RE: SUBMISSION TO DRAFT MAMRE ROAD PRECINCT DEVELOPMENT CONTROL PLAN

Submission to the Draft Mamre Road Precinct Development Control Plan

Frasers Property Australia Pty Limited

99-217 Aldington Road, Kemps Creek (Lots 33-37 DP 258949 and Lots 25-28 DP 255560)

Figure 5 Section of the proposed freight network and riparian corridor

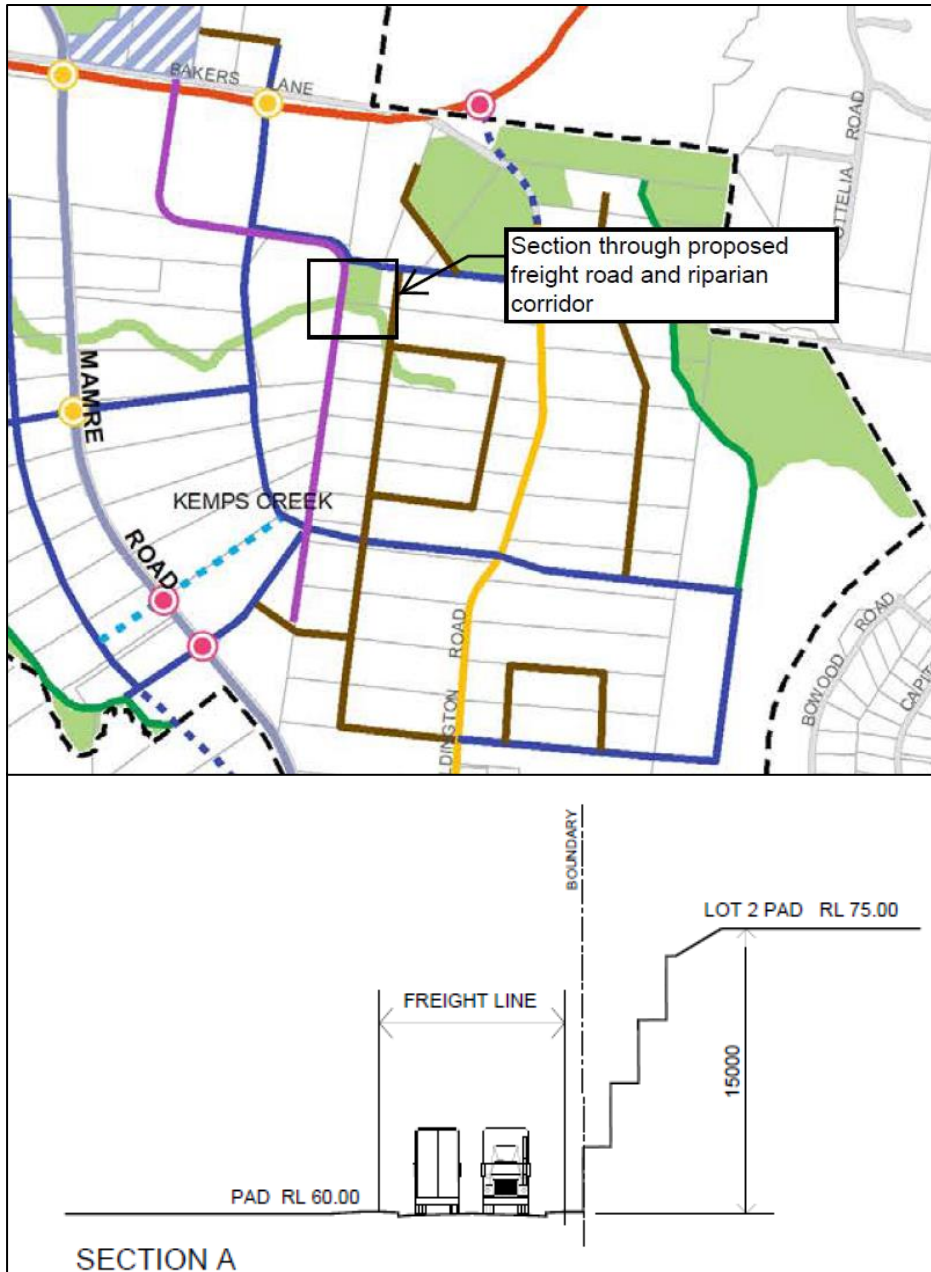
Consideration should be given to the impracticality of a continuous E2 riparian zone and CPW area integrated with the dedicated freight route proposed by Transport for NSW (TfNSW) and proposed pad levels (with efficient cut to fill excavation works), all to achieve a standard typical warehouse footprint. Refer to **Figure 5** below.

Upon review of the provisions of Sections 2.2 and 2.5, the abovementioned development controls are impractical to industrial and warehouse development. Specifically, future development on the site will be required to provide a 5m landscape setback, a 20m vegetated riparian zone on each side of the riparian corridor, as well as a managed buffer zone and APZ outside the vegetated riparian zones.

While this Submission acknowledges DPIE's intention to preserve and protect the identified riparian corridor and its biodiversity values, it is noted that the aforementioned controls impose stringent setback and buffer requirements on the site, which would significantly inhibit the development potential of the site and thus result in a considerable loss of productive industrial land. Moreover, future development on the site is also restrained by the ridgeline and steep topography of the site, which is further discussed in **Section 3.3** of this letter.

Figure 6 Amended extent of E2 zoned land

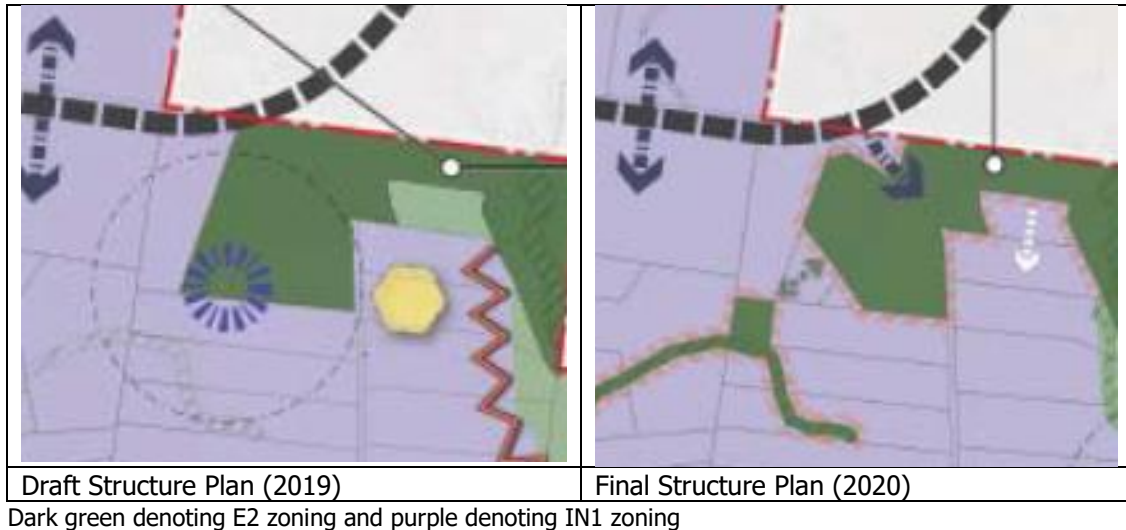
In particular, the amended extent of E2 zoned land on Lot 39 DP 708347, under the draft Structure Plan was wholly proposed as E2. The final Structure Plan amended this in response to landholder objections (as shown in **Figure 6** below). Notwithstanding, the 'opportunity for ecological corridor' that extends from Lot 37 DP 258949 and dissects the southern end of Lot 39 708347 will be constrained as a result of the proposed high order and internal roads proposed under the DCP (via input from TfNSW and PCC).

Further, the hatched transition zone (shown in **Figure 6** below) coincides with and is in conflict with the proposed high order and internal roads proposed.

The indicative 'opportunity for an ecological corridor' shown as green arrows in **Figure 6** is over 200m in distance from Lot 37 DP 258949 and Lot 38 DP 708347 and greater than 300m from native vegetation on Lot 39 DP 708347. Native vegetation patch size as defined in the Biodiversity Assessment Method (BAM) includes native vegetation that has a gap of less than 100m from the next area of moderate to good condition native vegetation.

A gap of less than 100m is also used as a component of condition thresholds for Threatened Ecological Communities under the Commonwealth EPBC Act. On this basis, the currently mapped 'opportunity for an ecological corridor' is already challenged and will be further isolated by the proposed high order and internal roads proposed under the DCP and by TfNSW/PCC.

Figure 9 Landscape features and visually sensitive locations (DPIE 2020)

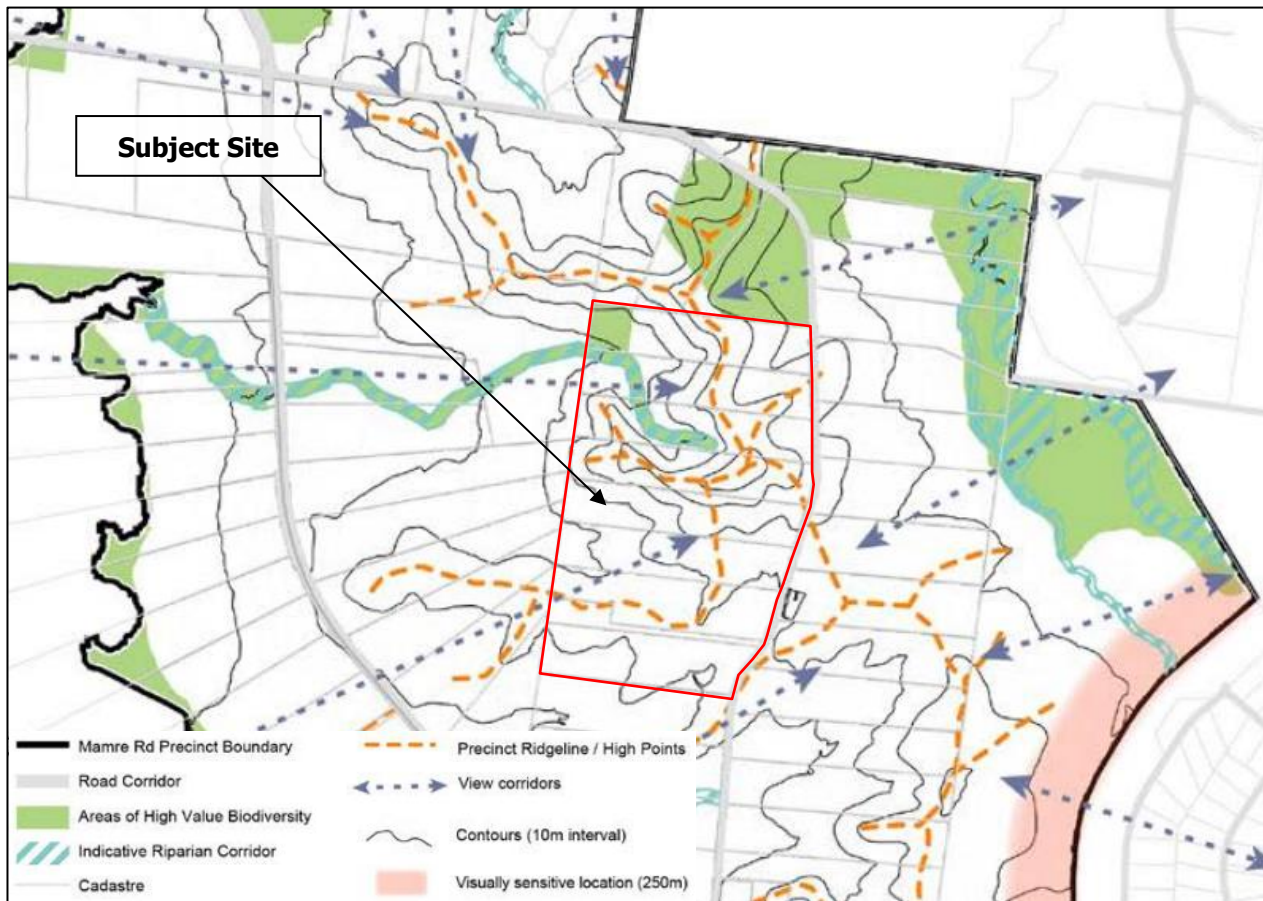
As depicted in Figure 10 in the Draft DCP (refer to **Figure 9** below), the site is located on land with the steepest topography in the Mamre Road Precinct. Given the construction and operational requirements of the future warehouse development, it is estimated that future development at the site will require 20 to 30m cut to fill to provide a suitable platform for future industrial development. Therefore, in order to carry out development at the site, bulk earthworks will be required to be undertaken which will impact on the physical characteristics of the land and remove the existing ridgelines.

While this Submission acknowledges the intention to respect the natural topography of the land, it is also important to recognise that the steep topography and physical characteristics of the land can be a physical constraint for developers to carry out development on the site, which would be unfeasible for industrial development and further inhibit the delivery of industrial land uses and employment-generating development in the Precinct. As such, it is requested that the objectives and controls of the Draft DCP be revised to acknowledge the constraints imposed by the topographic features on the delivery of employment-generating development in the Precinct.

Figure 10 Mamre Road Precinct Road Network Map (DPIE 2020)

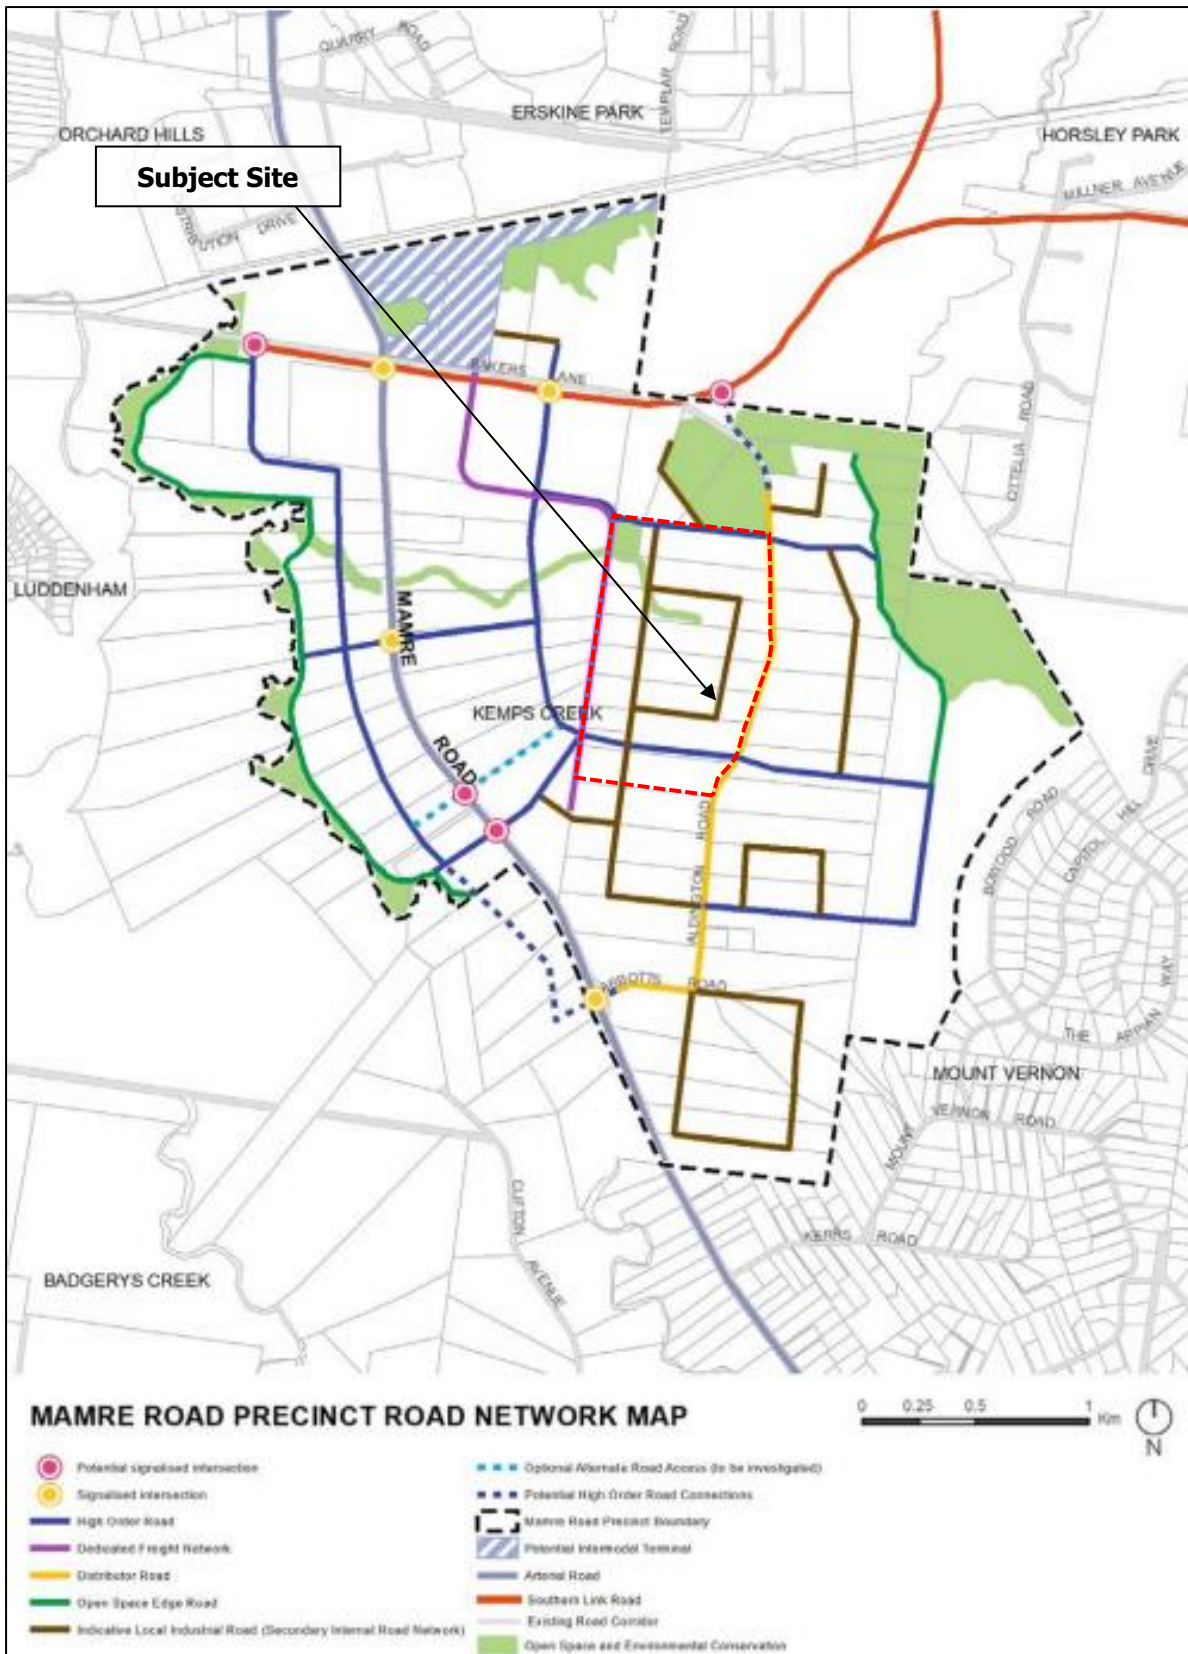
It is noted that the requirement to enable physical ground plane connection with the natural areas is impractical due to the topographical constraints on the land. In addition, as indicated in Figure 14 of the Draft DCP (refer to **Figure 10** below), the Draft DCP identifies a series of indicative road upgrades surrounding the site, including a dedicated freight network along the western boundary, higher order roads on the northern and southern boundaries and a local industrial road network within the site. Aldington Road is also identified as a distributor road.

Given the indicative road infrastructure requirements and the topographical constraints, it is deemed illogical to provide physical ground plane connections between the development and natural areas. It is considered that physical ground plane connections would be more appropriate to the western portion and other portions of the Mamre Road Precinct that affords an interface with a green open space. Notwithstanding, future development on the site will be designed to facilitate connectivity to the natural areas where appropriate to ensure the amenity of the built environment for workers.

Figure 11 Site level section

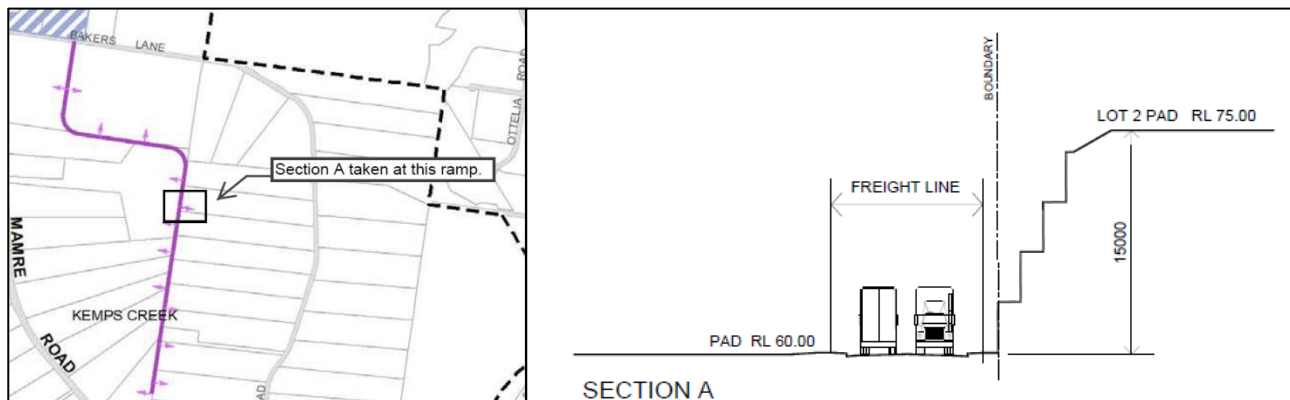
Section 3.4.3 identifies the indicative access points to the integrated freight network. It is noted that the indicative access points are located in areas with a sloping topography. A Section of the site levels is provided in **Figure 11** below. It is considered that the ramp locations are not practical with respect to the proposed and existing site levels. Given the topography of the site, it is noted that extensive cut and fill works will be required to facilitate access to the integrated freight network. While future development will be designed to support the delivery of the integrated freight network associated with the Western Sydney Intermodal Terminal, it is requested that the location of the indicative access points be revised working with the relevant landowners and with consideration to the topography of the land, as well as existing and proposed site levels of the site.

Figure 12 Retaining wall design

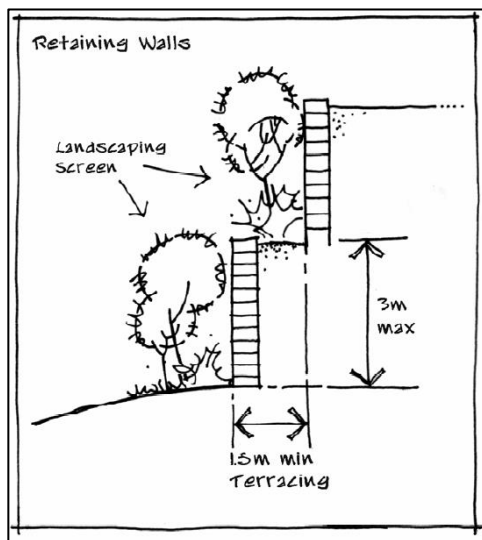
Subclause (4), (5), (6) and (7) retaining walls located on the front boundary adjacent the public road or domain being only 1.0mtr high is unrealistic. Clarification is required to confirm the intent of this clause retaining walls facing public roads should be no higher than 3.0mtrs tiered with a 1.5mtr terrace to further tier until top of pad level achieved.

Retaining walls out of public view and back of house should be able to be constructed without tiering and limitless height with engineering certifications.
